TECHNICAL SERVICE BULLETIN

NO. 180-001

SUBJECT: 70729 OIL SEAL

SUBJECT: A-95327 CARBURETOR HOUSING

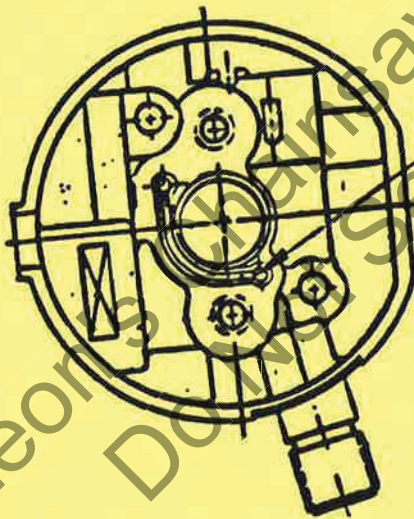
Some A-95327 carburetor housings have been found that have a thin wall of plastic material in the fuel transfer passage (See picture below for location).

This blockage will cause a unit to starve for fuel. These parts have been found in service parts stock in the field. Service parts stock at the B.D.C. has been checked and all incorrect parts have been removed.

Blockage
Here

Please check your stock. If any housings are found with this wall, it can be broken out with a sharp object.

SUBJECT: REPLACEMENT PARTS FOR HOMELITE 404 PITCH SAW CHAIN

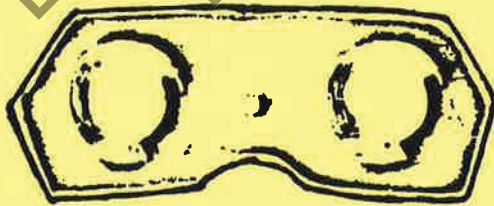
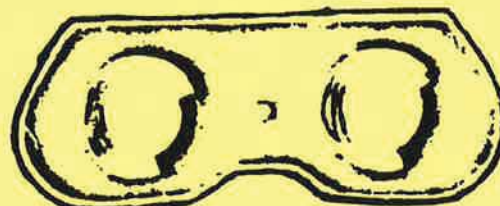
The following parts in the G-series, for 404 pitch chain with tie straps shaped like the one pictured below in the "G" series column, will be superseded by the "K" series which will repair both G & K series chain with the exception of the cutters.

<u>DESCRIPTION</u>	<u>OLD NUMBER</u>	<u>" SUPERSEDED BY"</u>	<u>NEW NUMBER</u>
	<u>404 PITCH</u>		<u>404 PITCH</u>
	(G-SERIES)		(K-SERIES)
Drive Link	40AL64-3G		40C63-3K
Tie Strap	40AL63-4G		40C63-4K
Rivet	40AL63-5G		40C63-5K
Preset Tie Strap	40AL63-6G		40C63-6K
Repair Kit	40AL63-7G		40C63-7K
Joining Kit	40AL63-8G		40C63-8K

COMPLETE ASSEMBLY #A-93597

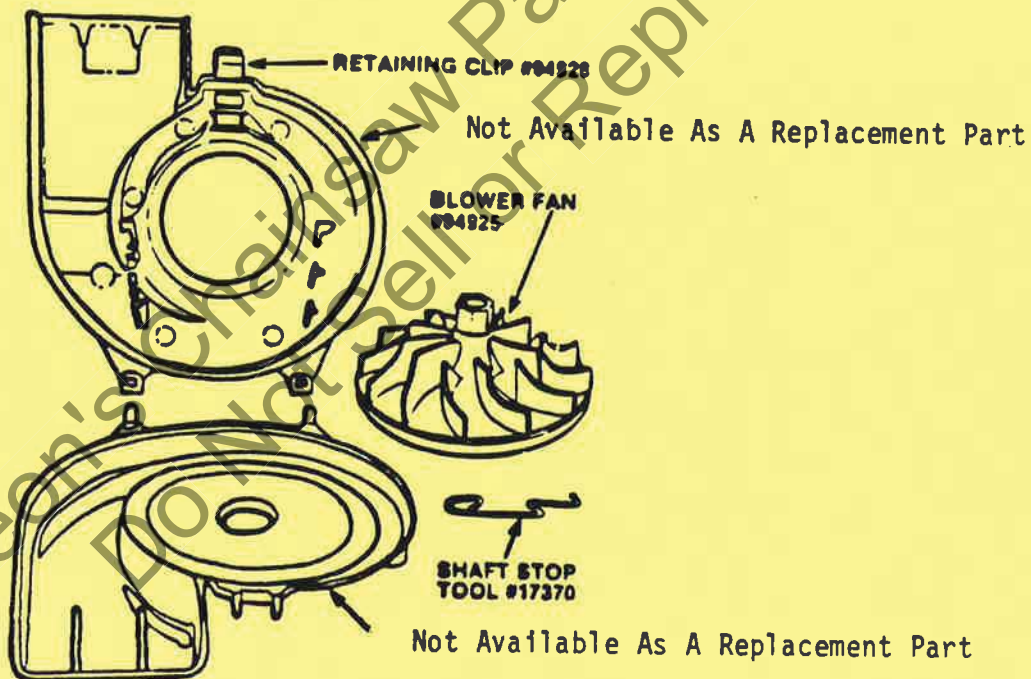
1. Instruction sheet #17400, included with the ST-100 blower, shows the blower housing as being available separately. This is a misprint. Refer to the parts list below when ordering parts.

COMPLETE ASSEMBLY #A-95800

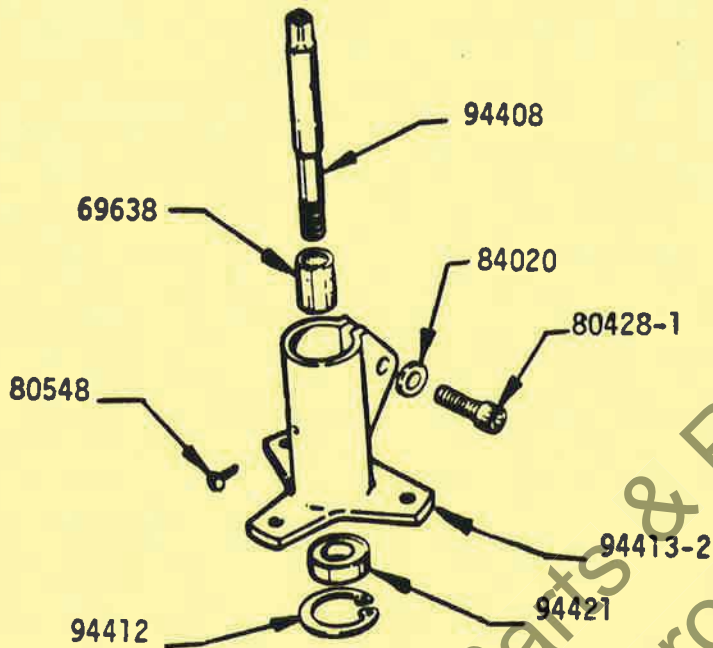
2. The ST-200 lower head housing and related parts as shown in figure 4 of the ST-200 parts list #17435 is now available as an assembly. The part number is A-95800. Refer to the parts list on the back of this page when ordering parts.

Please adjust your parts list accordingly.

ST-200/ST-210 BUSHING KIT #A-96064

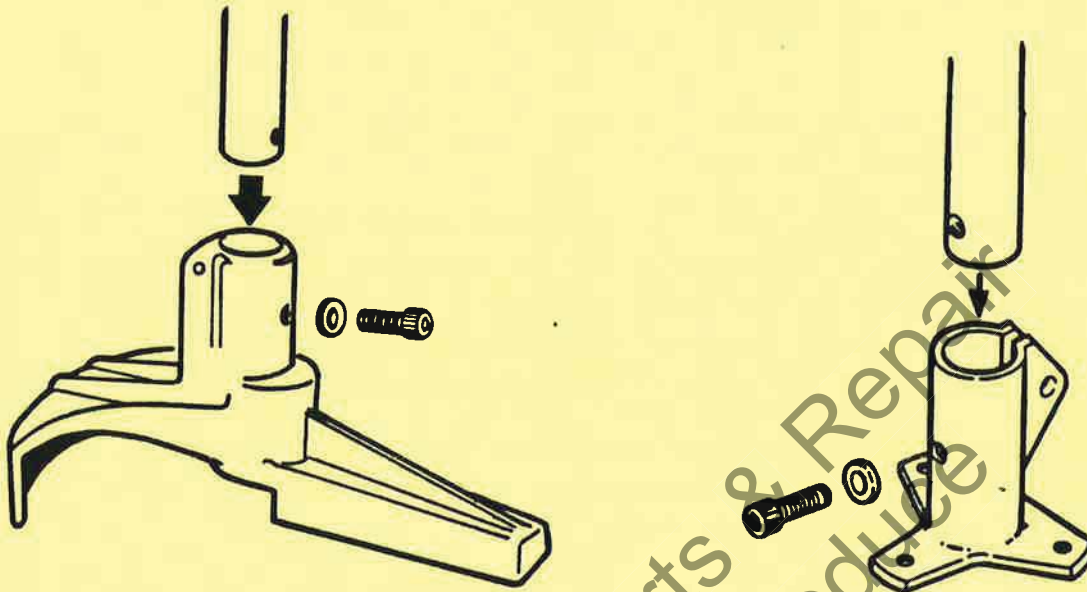
1. If you have one or the other of the above attachments on your unit, remove the attachment. Discard the small #6 alignment screw that is in the front of the housing.
2. Clean all grease from the lower end of the drive shaft tube.
3. Drill a 9/32 hole (7mm) through the existing hole on the side of the drive tube (where the #6 screw was removed).
4. Line up the threaded hole in the bushing with the hole in the drive tube. (See illustration.)

5. Install the bushing in the drive tube. The beveled edge of the bushing goes in first. If the bushing will not slide in the drive tube, tap it in with a plastic mallet. The bushing should not protrude from the drive tube.
6. If the head assembly does not have a large hole in the front of the housing, drill the existing hole out with a 9/32 drill bit (7mm).

7. Make sure the metal chips are cleaned out of the assembly before reinstalling the drive tube.
8. Install the tube into the lower head assembly until it bottoms. Align the hole in the head assembly with the hole in the drive tube.

9. Install the flat washer onto the socket head screw. Install the screw into the tube. Torque the screw to 80-100 inch-pounds (9.04-11.3 Nm).
10. Tighten the clamp screw on the back of the housing. Torque the screw to 80-100 inch-pounds (9.04-11.3 Nm).

SUBJECT: NEW STARTER ASSEMBLY

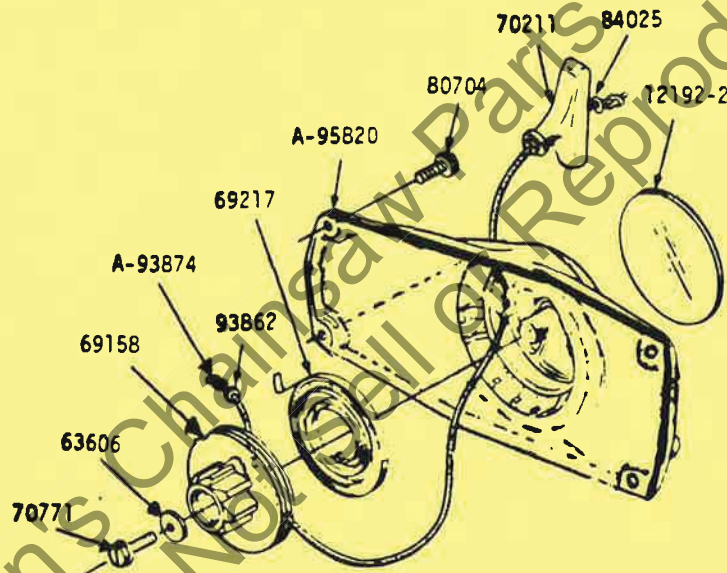
A new starter assembly is being introduced for the SEZ-A0. This new assembly uses a "fiberglass reinforced nylon" starter housing. All new units will have this system. Refer to the parts list below when ordering parts.

This system requires new starter pawls for the rotor. That new part number is 94336. The same rotor, springs, and studs will be used on both the new and old systems. Only the pawls have changed.

All parts for the old magnesium starter assemblies are still available from Service Parts. However, when the magnesium starter housings (part #A-65222-1) are used up a kit (part #A-95930) will be provided so that an easy change over to the plastic starter assembly can be made.

SUBJECT: CHAIN OILER OILS TOO MUCH

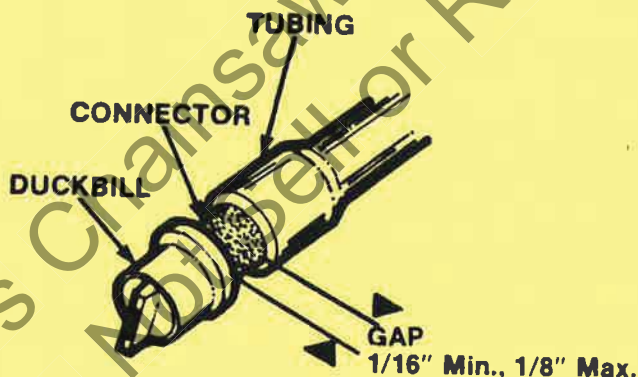
We have found some XL's that build too much pressure in the oil tank. This pressure forces excessive oil to the guide bar.

If a customer complains of too much oil being used during cutting, check the duck bill valve (69451); it may be against the pressure line. Pull the valve away from the line and expose at least 1/16, but not more than 1/8 of the connector (69656-1A).

This will allow the pressure in the tank to "bleed" back through the porous connector, when the unit is returned to idle or shut off, preventing too much pressure from building in the tank. See picture below.

SUBJECT: 1. THREE SHOE - LINED CLUTCH
2. HANDLE BAR

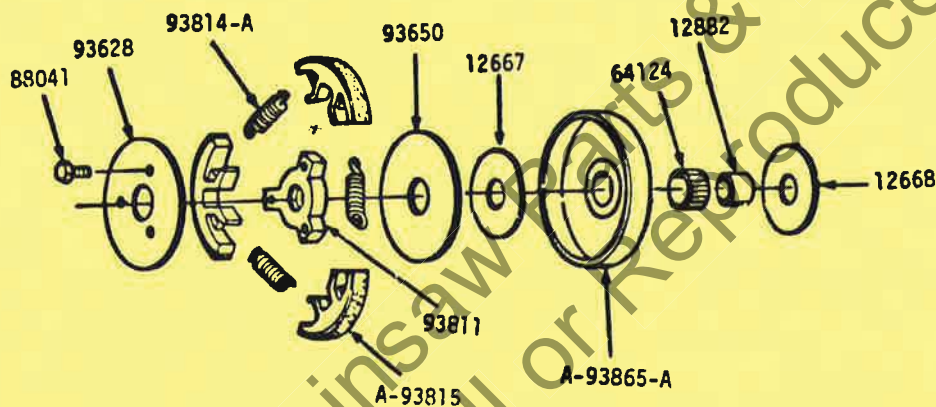
1. The 750-A0 is now being built with the new three shoe lined clutch. Refer to the parts list below when ordering parts.

The parts shown above are also available in a conversion kit, part #A-94157.

SUBJECT: BRUSHCUTTER KIT A-94479-A

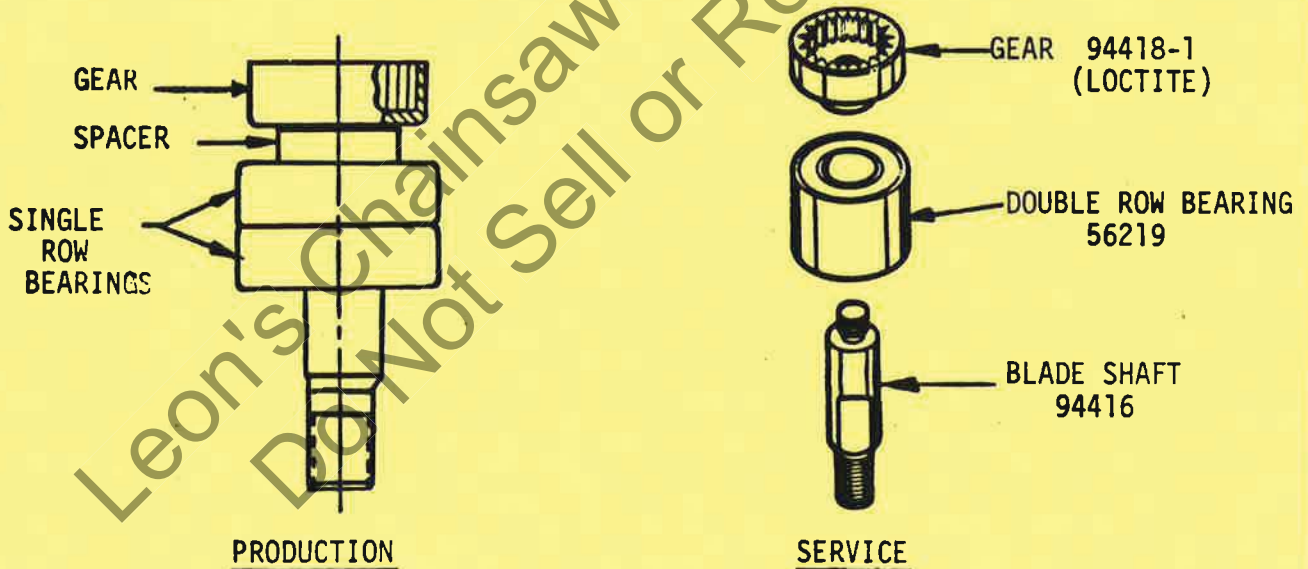
Some brushcutter gear heads (starting with serial number 800015657) have been produced with a blade shaft 94416 that has been assembled with two single row ball bearings and a spacer (see picture below).

We will continue to service the gear heads with the double row bearing as shown below.

SUBJECT: A-70532 CRANKSHAFT (BREAKER POINT IGNITIONS)
A-94712 CRANKSHAFT (SOLID STATE IGNITIONS)

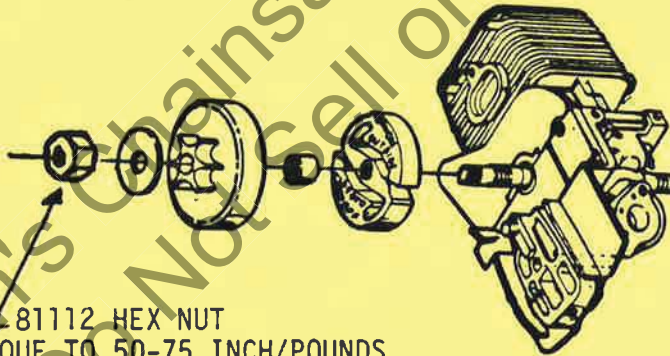
The retaining ring and groove on the clutch end of the above mentioned crankshaft is being replaced by a threaded end and a hex nut (see picture).

Units produced with a serial number of X0290XXXX and above will have this change.

Service will continue to supply the crankshaft with grooved clutch ends until the supply is exhausted. Then crankshafts with threaded clutch ends will be supplied.

SUBJECT: SERVICE TOOLS

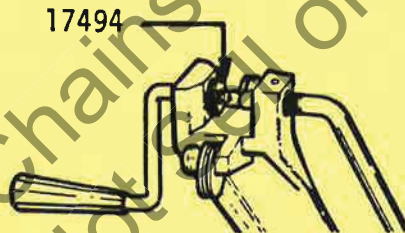
B. The anvil drive bushing for the spinner crank is now available. The part number is 17494. (See picture below).

SUBJECT: WIRES SHORTING ON G SERIES GENERATORS

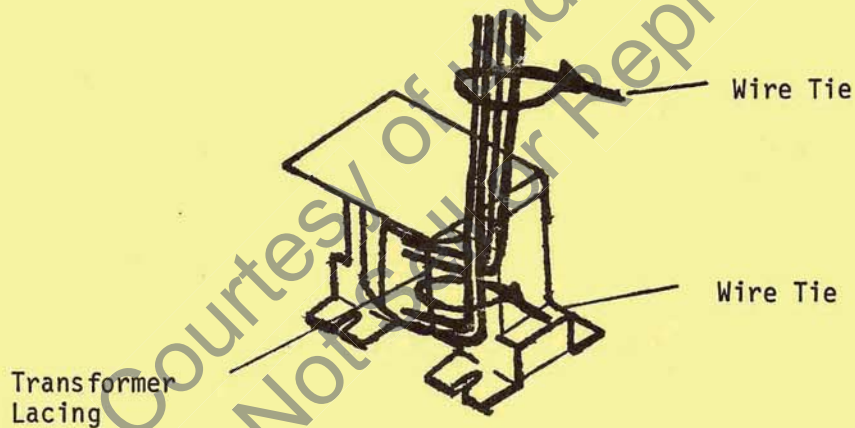
To prevent the transformer wires from shorting on the stator, a wire tie must be installed on the transformer as shown in the picture below. The wire tie will tie the lower wires to the transformer lacing. A second wire tie should be installed on the wire to keep them bundled as illustrated.
